UNITED STATES PATENT AND TRADEMARK OFFICE

APPLICATION NO.	FILING DATE	FIRST NAMED INVENTOR	ATTORNEY DOCKET NO.	CONFIRMATION NO.
10/665,578	09/19/2003	Jeffrey Zhang	31132.159	6445

Office Action Summary	Application No. 10/665,578	Applicant(s) ZHANG ET AL.	
	Examiner Nicholas Woodall	Art Unit 3733

Figure 1

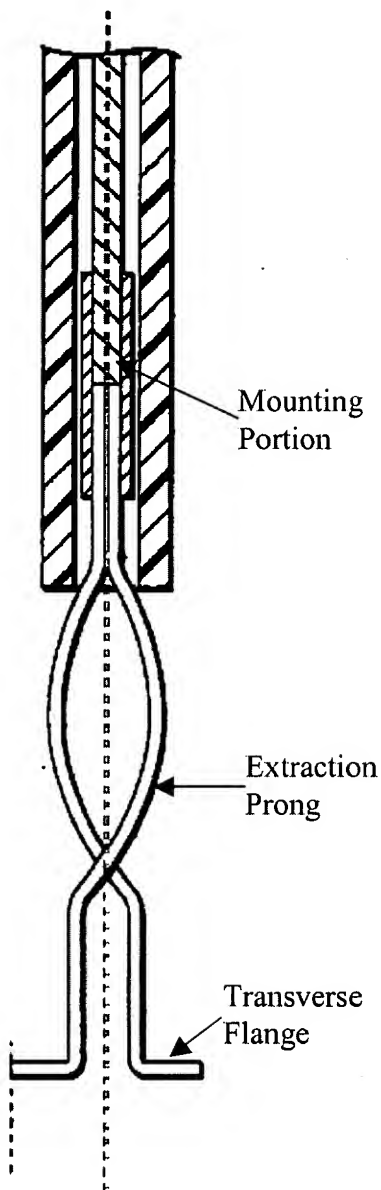
Regarding claim 1, Ouchi discloses a device comprising a distal portion and a proximal portion. The distal portion is capable of transitioning between an insertion configuration and an extraction configuration (reference Figure 1 below). Regarding claim 2, Ouchi discloses a device wherein the distal portion comprises at least one engaging member. Regarding claims 3 and 4, Ouchi discloses a device wherein the engaging member is manufactured from a flexible material such as stainless steel (pages 1 and 2 paragraph 16). Regarding claim 5, one definition of a block from www.dictionary.com is a solid mass of wood, stone, etc., usually with one or more flat or

approximately flat faces. Using this definition, Ouchi discloses a device wherein the engaging members are secured to a mounting block. Ouchi discloses the engagement members are fastened to a solid connector tube at the basal end. Regarding claim 6, Ouchi discloses a device wherein the engaging member comprises of an extraction prong. Regarding claims 7 and 8, Ouchi discloses a device wherein the extraction prong comprises a transverse flange with a hook-shaped configuration. Regarding claim 9, Ouchi discloses an invention wherein the transverse flanges extend in opposing directions. Regarding claim 10, Ouchi discloses an invention wherein the transverse flanges extend in parallel directions. Regarding claim 11, Ouchi discloses a device comprising at least one extraction prong comprising a transverse flange and a mounting portion for securing the extraction prong. Regarding claim 12, Ouchi discloses a device wherein the extraction prong is capable of transitioning between an insertion configuration and an extraction configuration. Regarding claim 13, Ouchi discloses a device wherein the transverse flange defines a reduced transverse profile. Regarding claim 14, Ouchi discloses a device wherein the transverse flange comprises a hook-shaped configuration. Regarding claims 15 and 16, Ouchi discloses a device wherein the extraction prong is manufactured from a flexible material such as stainless steel (pages 1 and 2 paragraph 16). Regarding claim 17, Ouchi discloses a device wherein the mounting portion comprises a mounting block as discussed above. Regarding claims 18 and 20, Ouchi discloses a device with a distal portion comprising a transverse flange that is inherently capable of being used a method comprising the steps of inserting a surgical instrument having a distal portion able to transition from an insertion

configuration to an extraction configuration, transitioning the distal end to the extraction configuration, engaging the distal portion with an implant, and exerting an extraction force to extract the implant. Regarding claim 19, Ouchi discloses a device that is inherently capable of being used in the method of claim 18 further comprising the step of displacing the distal portion along at least a portion of the implant. Ouchi shows the device being displaced inside an implant before actuating the implant and exerting an extraction force on the implant.

Figure 2

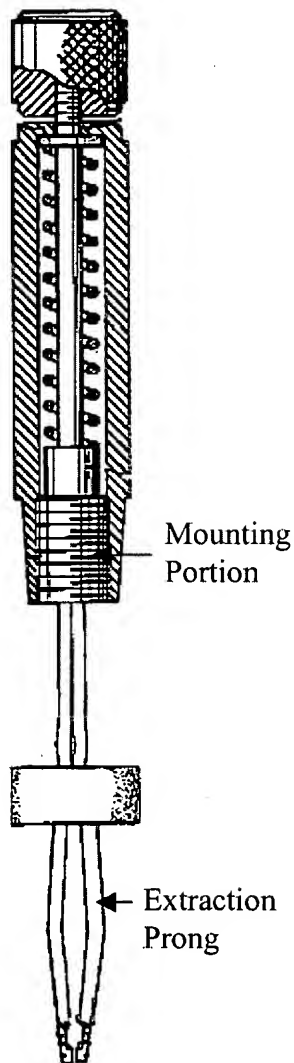
Regarding claim 11, Bauer discloses a device comprising at least on extraction prong with a transverse flange and a mounting portion to secure the extraction prong

(reference Figure 2 below). Regarding claim 17, Bauer discloses a device wherein the mounted portion comprises a mounting block.
